A428 Black Cat to Caxton Gibbet improvements

TR010044

9.53 Applicant's comments on the WSP Technical Note in relation to the Roxton Road Link

November 2021

Figure 1.9 – Alternative alignment from WSP Technical Note

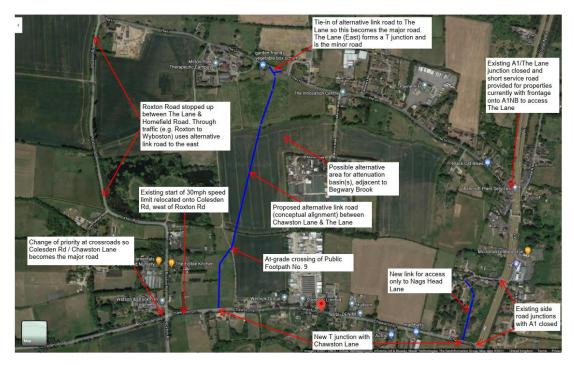
1.3.17 The WSP Technical Note has suggested an alternative location for a new road starting further west along The Lane. This was commented on in the response to Written Representations submitted by the Applicant at Deadline 3 [REP3-008]. A small version of this is copied below in Figure 1.9.

- 1.3.18 An alternative such as this was not developed because a new road to the west would have to avoid the site of the scheduled monument immediately west of Dove Farm, so would be too remote to provide reasonable access for the Nagshead Lane properties and the residential properties along the A1 to the north, whose access arrangements are discussed in Section 1.3. An option like this would not provide access to the Gleneden site. Rather than being on the edge of a rural settlement, a route to the west would cut through open fields and would sever public footpath No. 9, which is designated as the Ouse Valley Way.

- 1.3.19 A route to the west would also involve the following:
 - a. Widening of The Lane over a length of at least 750m from the HE Payne haulage yard and inclusion of a footway/cycleway. This would require acquisition of residential gardens on one or both sides of the road fronting The Lane.

- b. Widening of Chawston Lane from the Wernick Plant hire yard over a length of 470m (please note that this is different to the value of 770m quoted in REP3-008, which was an error and a repetition of the 770m value quoted below relating to the sweeper hire premises) to the junction of Chawston Lane and Roxton Road and inclusion of a footway/cycleway. This would in places require acquisition of residential gardens and parts of commercial properties on one or both sides of the road fronting Chawston Lane. Widening may even be required further east over approximately 770m, to the road sweeper hire premises.

- c. Roxton Road would need to be widened over a length of approximately 470m and include a footway/cycleway, from its junction with Chawston Lane through to the tie-in with the proposed roundabout that is being provided as part of the Scheme. This would require acquisition of agricultural land on one or both sides of the road and potentially parts of residential and commercial properties fronting Roxton Road.

- d. South Brook passes beneath this section of Roxton Road and the culvert carrying South Brook would need to be extended to accommodate the road widening.

- e. The proposal for Nags Head Lane would require acquisition of parts of residential gardens and also part of the field to the south. It would not provide a suitable route for the reasons discussed in Section 1.3.

- f. The proposal caters for the bungalows that front the A1 just south of The Lane but does not cater for access from the two residential properties further south, but north of Nags Head Lane. These two properties would either be completely isolated and would have to be acquired by the Applicant, or would require continued direct access to the A1 northbound carriageway. Neither scenario is considered acceptable.

- g. The proposed main route would sever a public footpath and would cross diagonally across agricultural fields.
- h. The proposal ignores that access is still needed for properties to the south, including the Gleneden plant hire site and adjoining land, which currently have direct access to the A1 northbound carriageway, just north of the existing Black Cat roundabout. A new route of at least 780m is needed to provide this access regardless of where the route to The Lane is to be located.

- 1.3.20 To summarise, although there are alternative routes, including the WSP alternative, none of these would be as efficient or desirable in terms of effectiveness in providing one single route to give access to as many properties as possible, minimising environmental effects as far as possible and using the least amount of land as reasonably practicable.
